REFLECTION RIDGE WEST

AN ADDITION TO WICHITA, SEDGWICK COUNTY, KANSAS

RE: SUB 2000-91 -- One-Step Final Plat of REFLECTION RIDGE WEST ADDITION

CASE NUMBER: SUB 2000-91 -- REFLECTION RIDGE WEST ADDITION

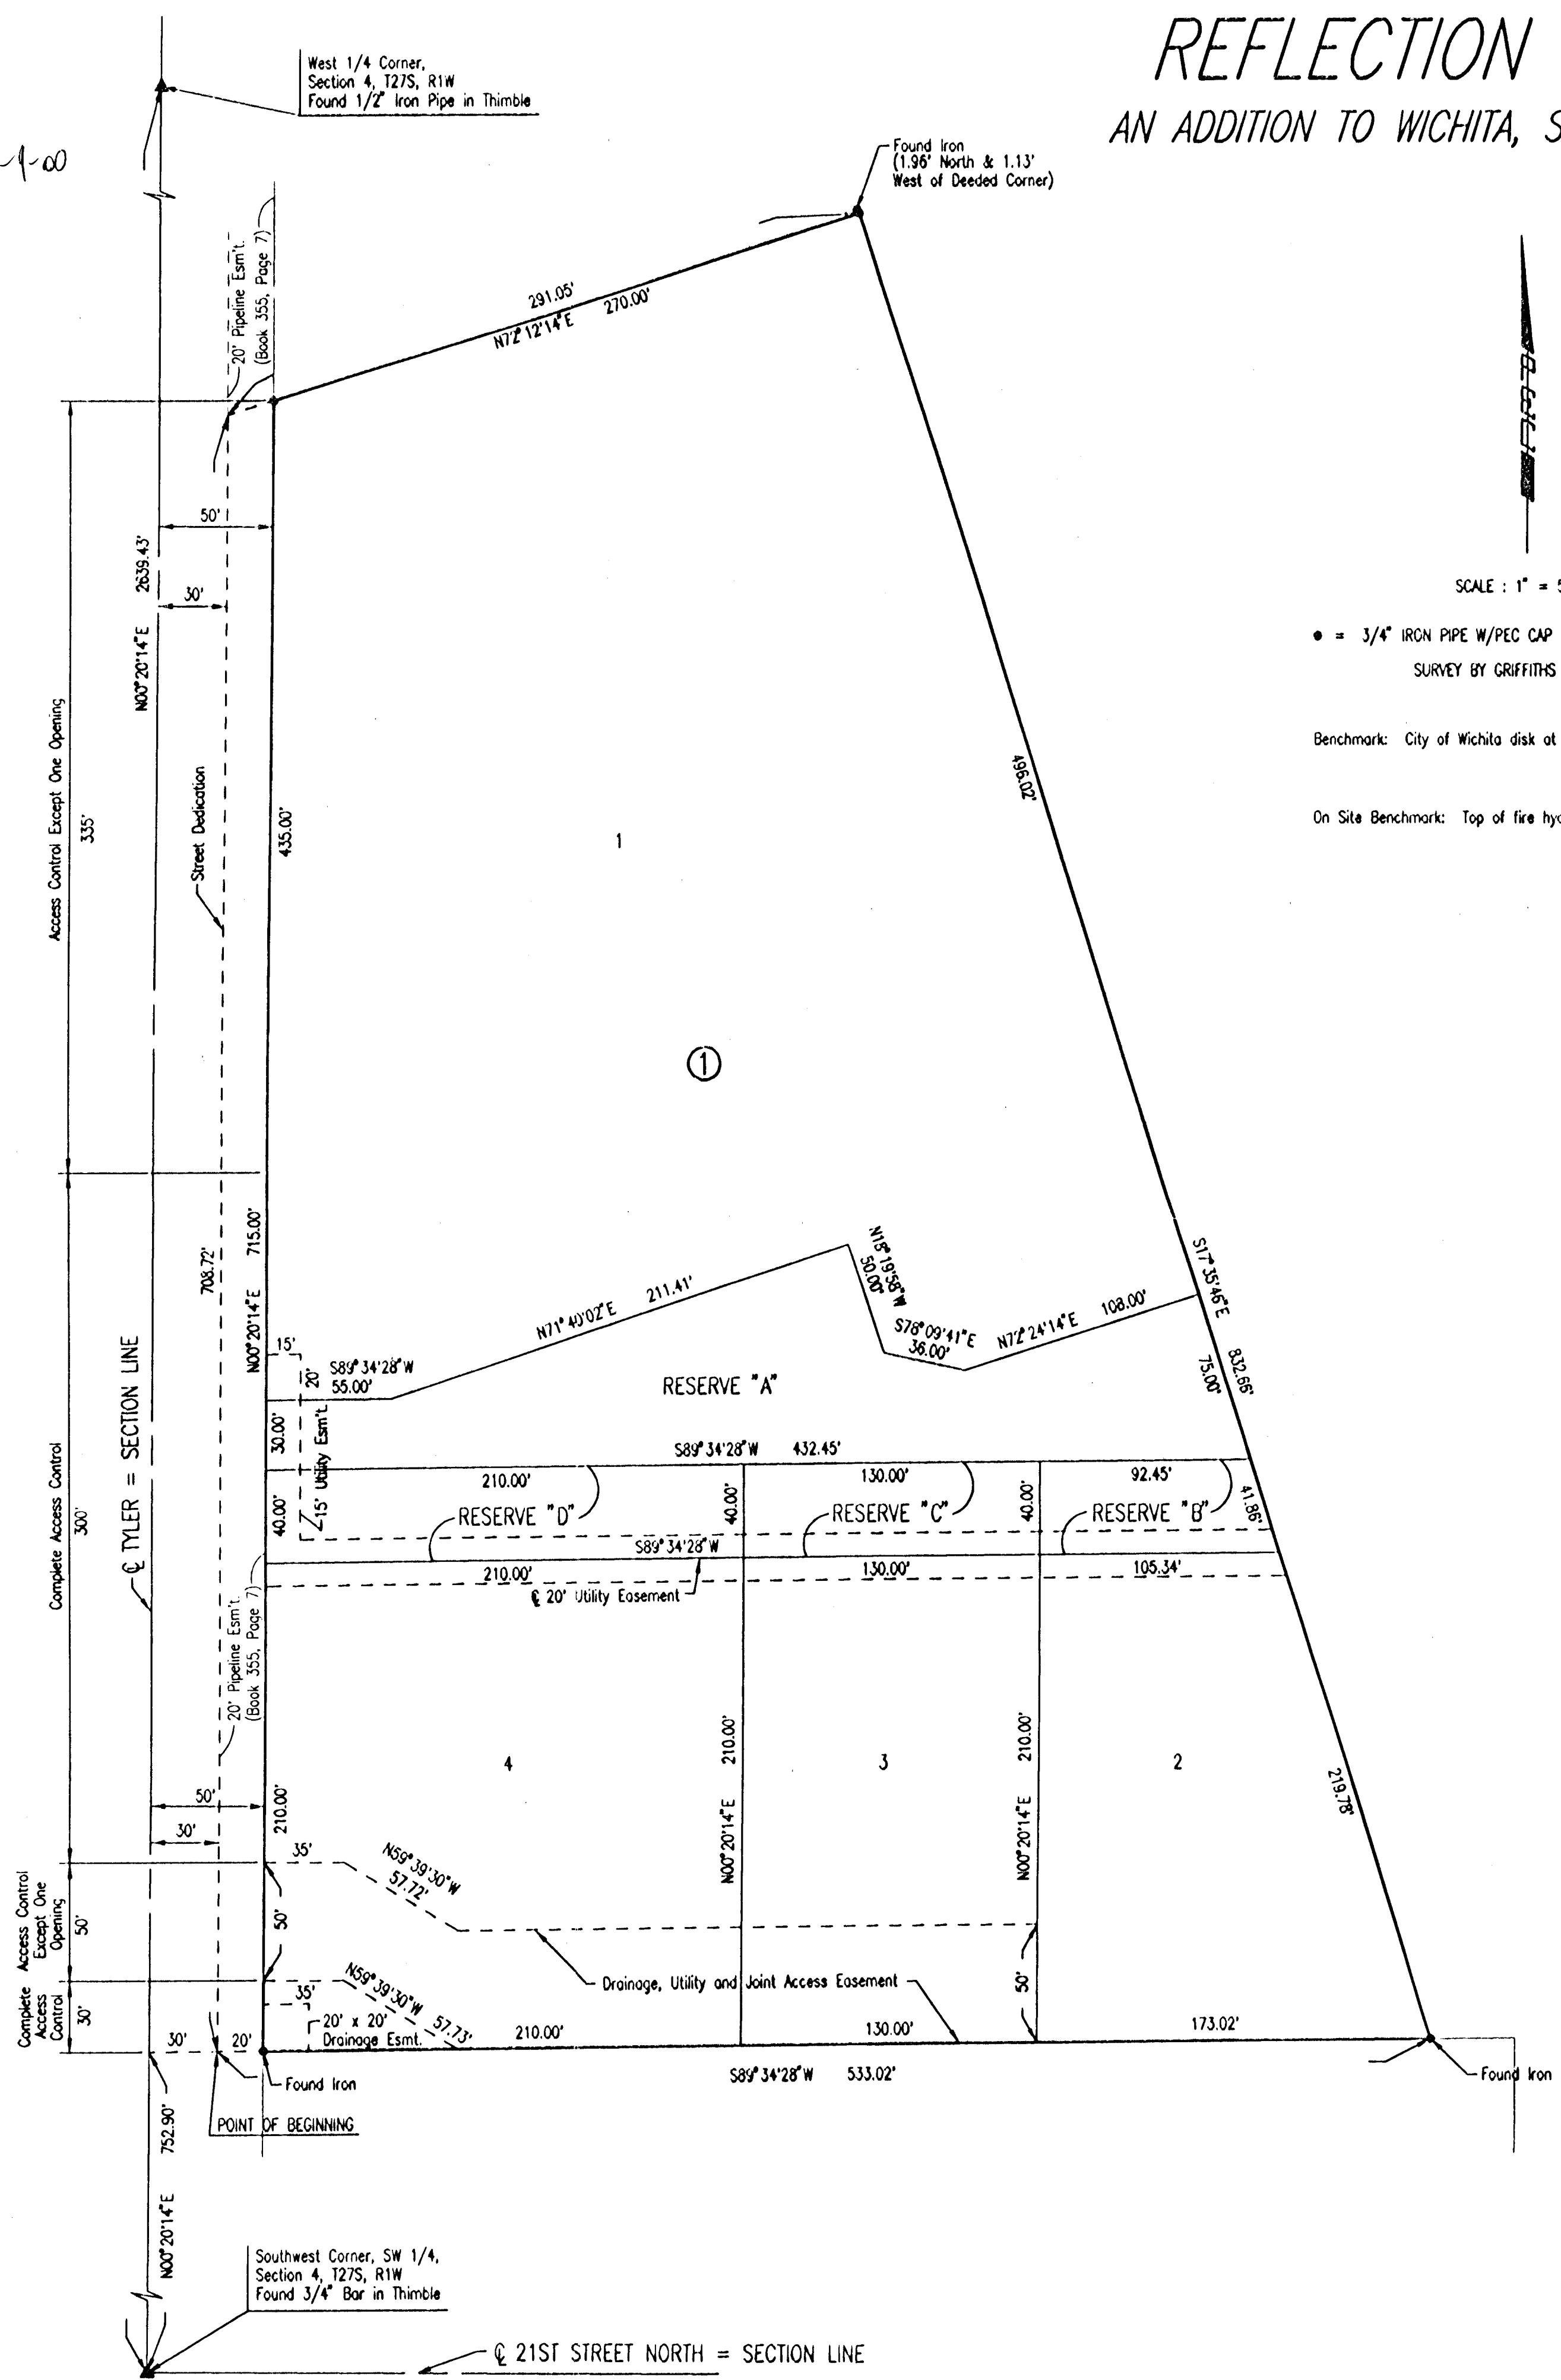
- C. City Engineering needs to comment on the status of the applicant's drainage plan and the need for a Reserve for the proposed lake between the two lots. The drainage plan is approved. A guarantee is required. The final plat tracing shall denote a Reserve between the lots for the lake denoted on the CUP site plan.

- D. In accordance with the CUP, the plat proposes one access opening per lot along Tyler. The CUP also required a 300-ft minimum separation between the openings which should be denoted on the face of the plat. The final plat tracing shall reference the access controls in the plat's text.

- G. The applicant's agent shall determine any setback requirements for the pipelines adjoining the property by researching the text of the pipeline agreements. If a setback from the pipeline easements is provided for in the pipeline easement agreements, it shall be indicated on the face of the plat.
